Hi-Fi Products
Service Bulletin

Model: D2, D4, DT4

No. 85

Subject: Rack and Motor Assembly Replacement **Date:** September 15, 1989

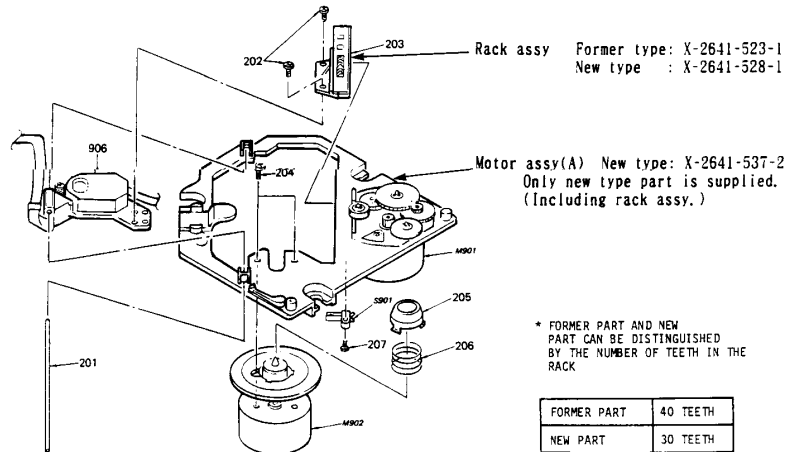
Symptom:
(**)

Old type of rack and motor gears may bind causing skipping or no play.

Solution: The rack and motor assemblies should be replaced with the new type of rack and motor assemblies listed below:

Note: There is no interchangeability between old and new type parts. Therefore, when replacing the motor assembly (A), the new type of motor and rack assembly must be used.

These parts are supplied together under one part number.

The new rack assembly is also available separately, but must only be used with the new motor assembly.
